Code Amendment Proposal Application

OSSC 22-17

Specialty code:	Oregon Structural Specialty Code (OSSC)
Code section(s):	3111.3.5.3.3

Briefly explain the subject of your proposal:	Clarifies the requirements for roof framing to qualify for prescriptive solar installations to enable uniform and consistent understanding and implementation of the prescriptive requirements for solar installation in the OSSC.
---	--

FIGURE 3111.3.5.2.3(1)

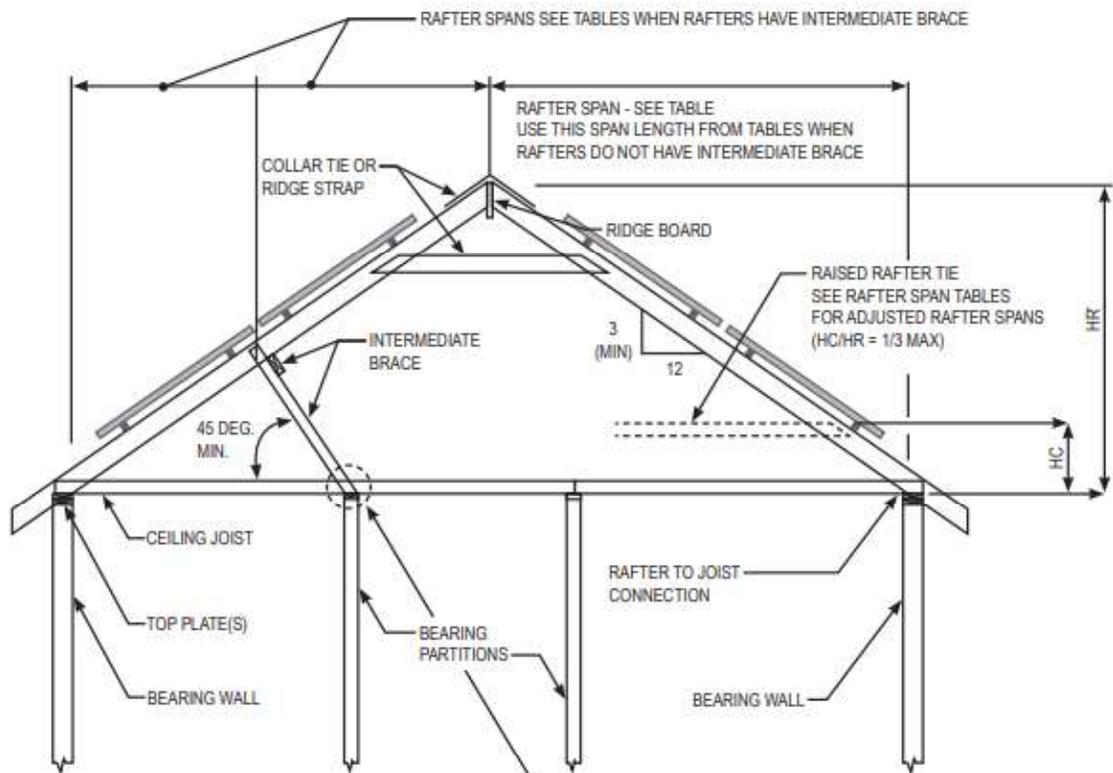
1.4 Existing rafter spans and ceiling joists shall comply with Sections 2308.7.1, 2308.7.2 and 2308.7.3. Where rafter spans are based on intermediate supports provided between the ridge and eave, such support or brace shall bear directly on bearing wall or partitions below. See Figure 3111.3.5.2.3(1)

Note: To qualify as an intermediate support or brace for rafters, the intermediate brace must bear on a bearing wall. Where the intermediate brace/support, bears on the ceiling joist, the intermediate brace shall not be considered as a support for rafters and rafter span shall be from exterior bearing wall to ridge.
